ADDRESS . . : 120 TACTICAL DR
CONTRACTOR : RBC HOMES INC
OWNER . . . : 210 HIGHWAY DEVELOPMENT LLC
PARCEL . . . : 01-0547- - -0024- -48-
APPL NUMBER: 08-50019161 CP NEW RESIDENTIAL (SFD)
DIRECTIONS : GWEN OAKS #48
210 SOUTH APPROX 4 MILES, SUB DIV ON
LEFT AFTER SCHOOL.
T/S: 01/09/2008 04:52 PM VBROWN ----

PERMIT: CPSF 00 CP * SFD

Re: J80310
Highland / Lot 48 Gwen Oaks / Harnett

Job	Truss	Truss Type	City	Ply	Highland / Lot 48 Gwen Oaks / Hamett	E4023038
180310	A1A	ATTIC	6	2	Job Reference (optional)

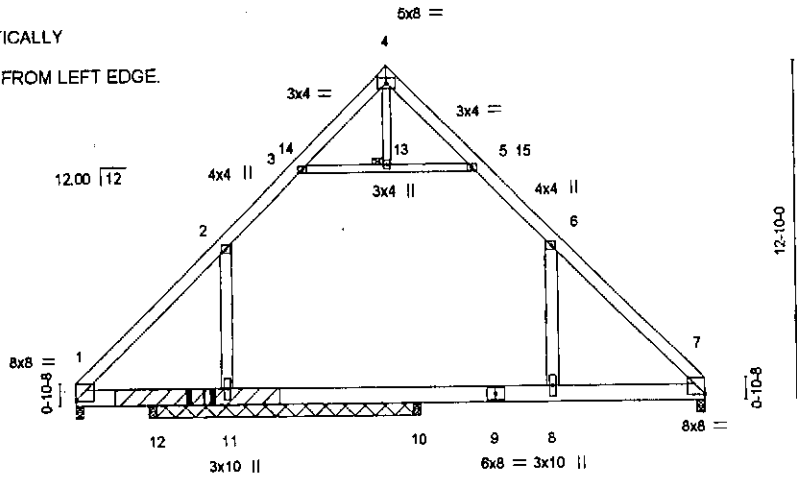
5/8" DIAM HOLES DRILLED VERTICALLY AT CENTERLINE OF 2 PLY B.C. AT 50", 52", 58", 61", 62" AND 63" FROM LEFT EDGE.

APPLY 2X8 X 6' - 0" SPF NO.2 SCAB TO ONE SIDE OF TRUSS CENTERED ON DAMAGE WITH 3 ROWS OF 10d (3" X 0.131") NAILS SPACED 3.0' O.C.
